ROAD SAFETY AUDIT REPORT

Stage 2 (Preliminary Design)

**Road Widening to Accommodate Right Turn
Deceleration Lane**

No. 321 GREENDALE ROAD, GREENDALE

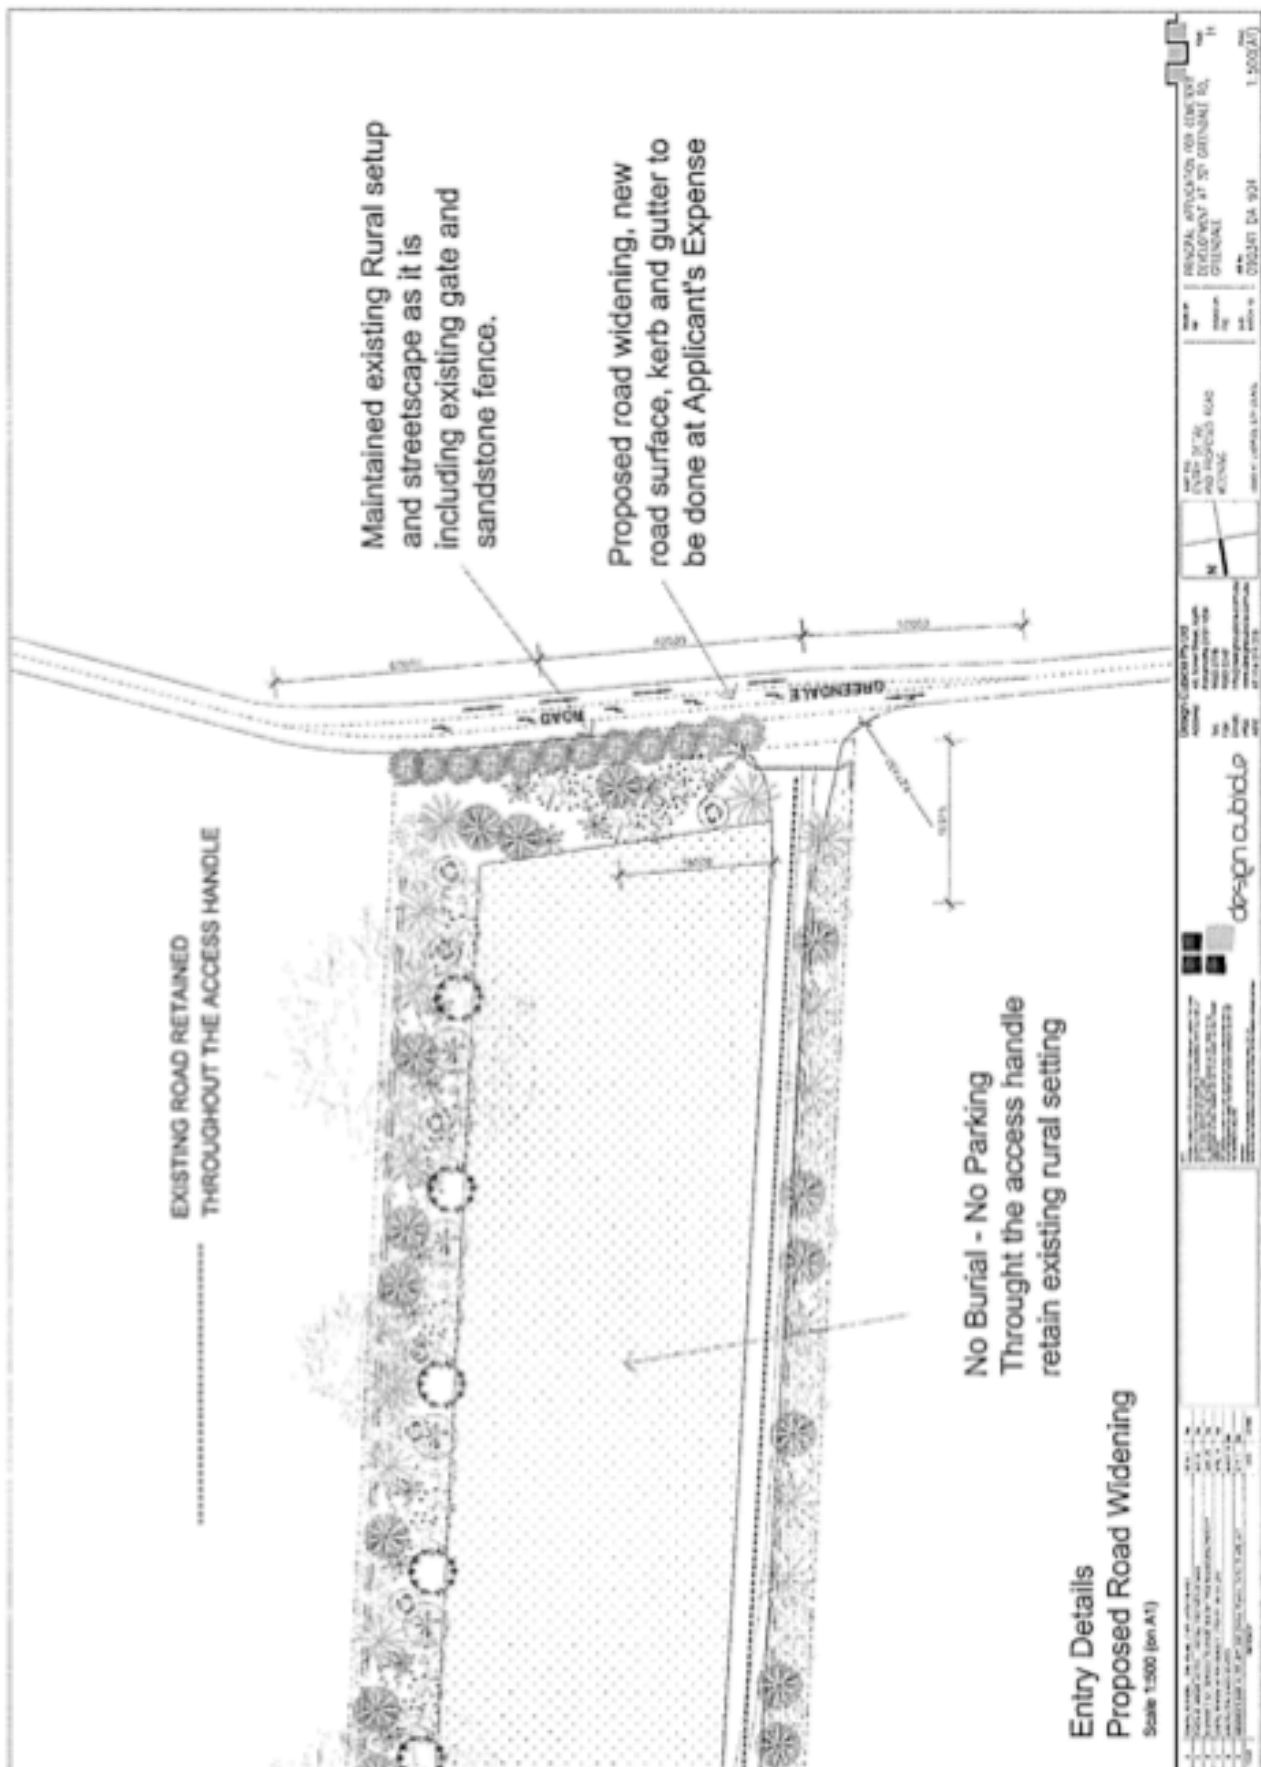
ROAD SAFETY AUDIT Stage 2 (Preliminary Design) Road Widening to Accommodate Right Turn Deceleration Lane No. 321 GREENDALE ROAD, GREENDALE				
Item No.	Location	Identified Deficiency	Priority	Recommended Treatment
1	At western property boundary	<p>Located approx. 20m to the west of the proposed development boundary is a vehicle driveway accessing a rural industry and further to the west residential access is also provided.</p>  <p>In addition to the east of the subject property driveway access is provided to residential properties on the northern side. Under NSW Traffic Regulations vehicles are prohibited from turning right across a painted median barrier. On this basis the proposed Preliminary Design prohibits westbound vehicles from turning right into properties impacted by the location of the painted central median proposed.</p>	H	Review proposed design to accommodate property access to the east and west of the subject development access driveway.

2	Driveway Access	<p>The existing gateway access measures approx. 3m. Given the type of development proposed there is a high probability the opposing vehicles will meet at the driveway access. The existing driveway can not accommodate passing vehicles and should entry vehicles conflict with exit vehicles this may cause queuing onto Greendale Road.</p> 	H	Widen access driveway to allow vehicles to pass at the gateway entry (i.e. two-way flow).

3	General	The design refers to kerb and gutter “to be done at the Applicants expense”. It is considered the applied design incorporating K&G and being a rural environment, does not maintain consistency of a rural road environment and may create a “hazard” especially at night in terms of driver expectation for through vehicles.	M	Kerb and gutter not required.
4	General	From Point 3 above particular attention will need to be given to ensuring drainage of pavement and water flow within the intersection is appropriately treated to avoid ponding.	M	Provide table drains and associated drainage to accommodate design storm-water run-off period. Headwalls if employed to be placed outside of the “clear Zone” for the regulated speed of the road.
5	General	If kerb and gutter is not to be employed in the design roadside shoulders should be provided and transition to existing shoulders.	M	Apply roadside shoulders (min 2m wide) and transition into existing.

6	General	Approach sight distance to be appropriate for the 85 th percentile free speed of each approach movement and measured 1.15m to Zero (due to pavement markings).	M	Apply appropriate site distance requirements.
7	General	Roadside furniture (especially signs) and plantings are not to interfere with sight distance requirements at the driveway access. This applies especially to the existing plantings along the frontage of the site.	M	Ensure appropriate intersection sight distances are applied to the design on all legs.
8	General	The proposed design is considered may bring traffic closer to non-frangible roadside furniture (poles, trees etc). All non-frangible furniture is to be located outside of the designated “clear zone” for the speed of the road or protected.	H	Apply ‘clear zone’ requirements to design to ensure safety.
9	Driveway access roadway	The existing driveway into the subject property is bitumen sealed. This should be indicated in the design and pavement designed in accordance with appropriate standards.	L	Desirably access driveway roadway should be sealed a minimum of 30m into the property and pavement designed to required Council standards.

10	West-bound approach	The design indicates the Westbound through movement will be moved to the south to allow provision of the right turn storage bay. Design standards for both horizontal and vertical alignment appropriate to the design speed should be applied.	M	The change of alignment requires attention to the design of the westbound vertical and horizontal alignment of the road.

Figure 4.5.6 - Type "CHR" Rural T Intersection Layout
General Details

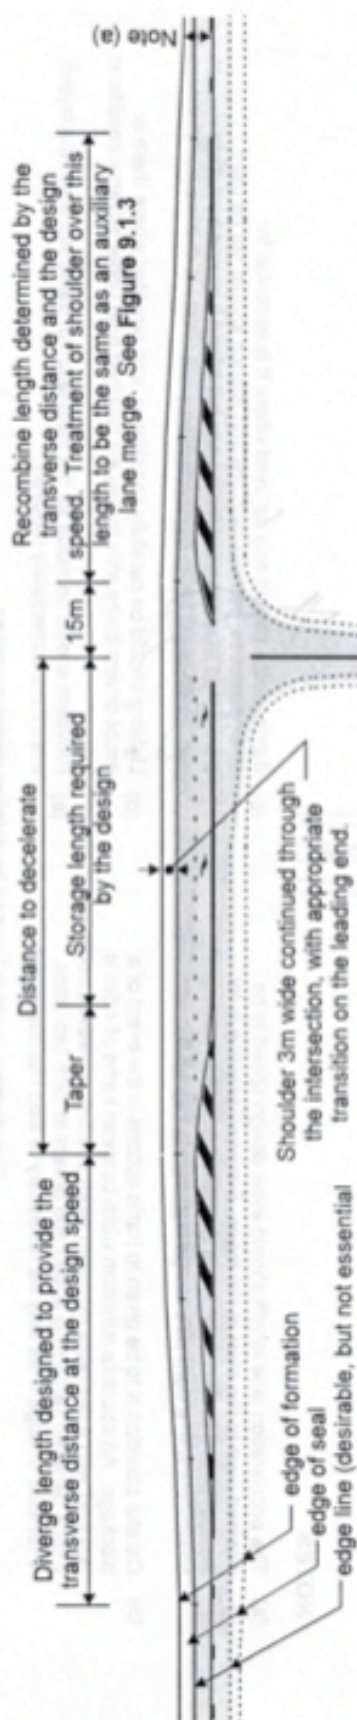
Secondly the above stated designs are for rural type treatments and for the right turn treatment relies on sealed pavement to support pavement markings to define the travel path of vehicles and is generally applied at complex sites with heavy, turning movements and accident blackspots which could be assisted by separation of movements.

Figure 4.5.3 - Rural Type "AUR" Layout

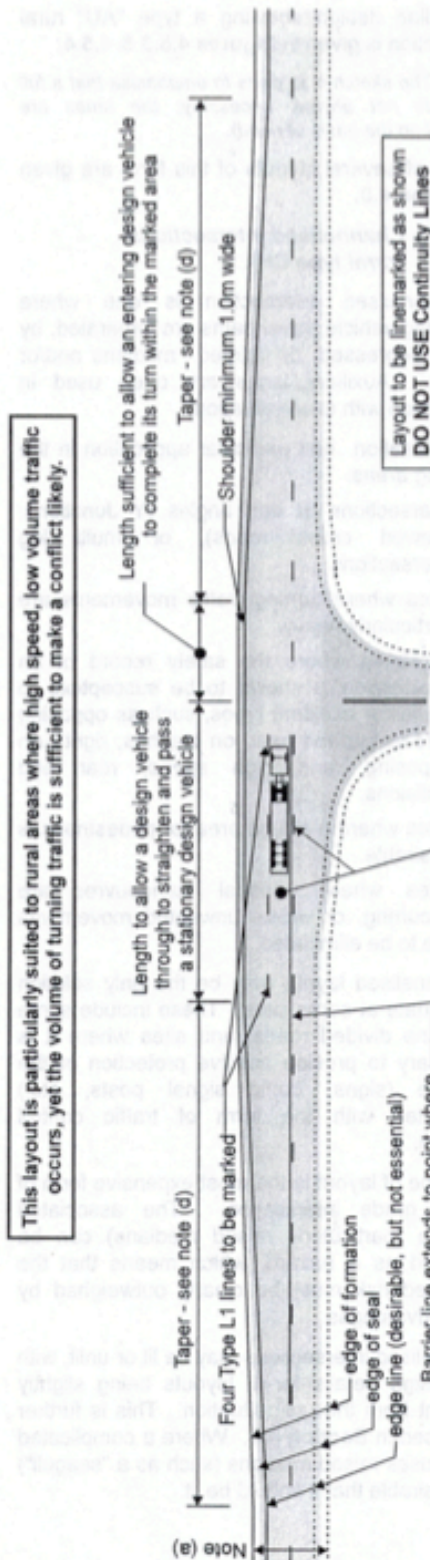
Based on the above consideration should be given to applying a reduced access for the development and a type AUR (**A**UXilliary lane **R**ight turn treatment) combined with the BAL already included is recommended (refer Appendix 5 for AUR treatment).
